Service Bulletin

LAUNDRY
ALL "HYDROWAVE" MODELS

HL 01-07

MOTOR-INVERTER DRIVE SYSTEM – 2 FLASH INVERTER BOARD ERROR (MOTOR APPEARS DEAD)

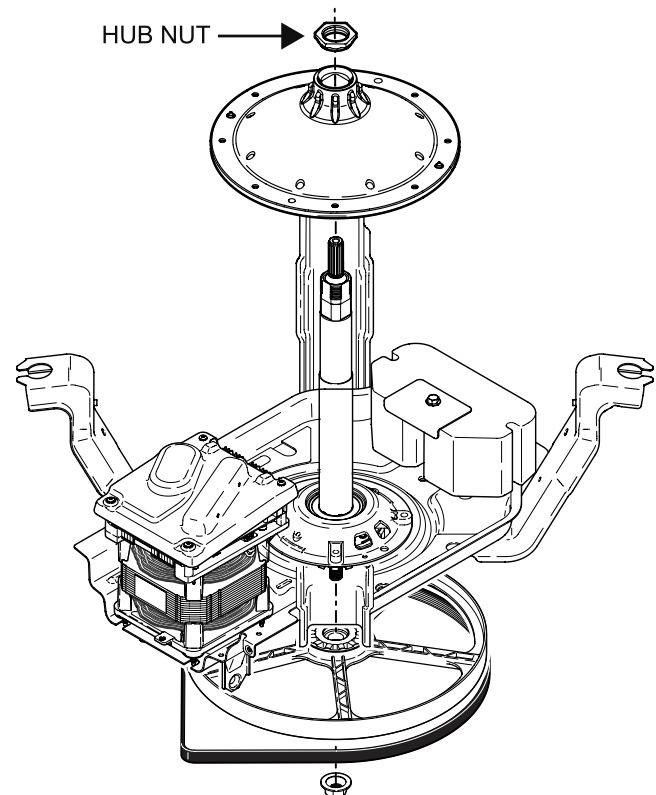
The **2 flash error** was intended to represent a slipping belt condition as identified in the mini-manual. Based on field feedback, a **loose hub nut** may also simulate the conditions that the inverter uses to detect a slipping belt condition. Because a slipping belt presents a safety concern for the machine to brake/stop normally, the inverter disables the motor while setting the **2 flash error** code. The motor will not agitate or spin in this condition, so the **motor appears DEAD**.

A **loose hub nut** may be obvious in severe circumstances where the basket has damaged the balance ring, the tub cover, or the tub. In some instances, it is more difficult to detect if the hub nut has not fully backed off. NOTE: The HYDROWAVE drive does not have a mechanical brake like the drive system with transmission. The basket may rotate freely depending on the state of the mode shifter assembly. It may require closer inspection of the hub nut. If the threads of the nut are damaged, the nut will not hold the tub securely. Always **replace the hub nut if any damage** is noticed. Tighten the nut to **110 ft. lbs**.

1. Remove the agitator and agitator coupling
2. Inspect for damaged components (replace as necessary)
3. Tighten the hub nut with a torque wrench or impact gun (current factory torque setting is 110 FT-LBS)

Clearing Motor-Inverter error codes:

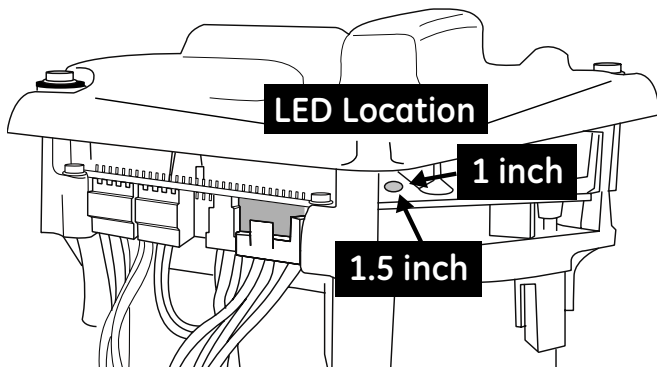
The LED is best viewed from the right front of the motor, 1.5" back and 1" into board.

1. Disconnect the washer from power and wait approximately 15 seconds (hear a click/capacitor discharge)
2. Reconnect the washer to power and allow the relay to click (approximately 2 seconds).
3. Open and close the lid 5 or more times (in any 12 second period within the first 30 seconds of power up)
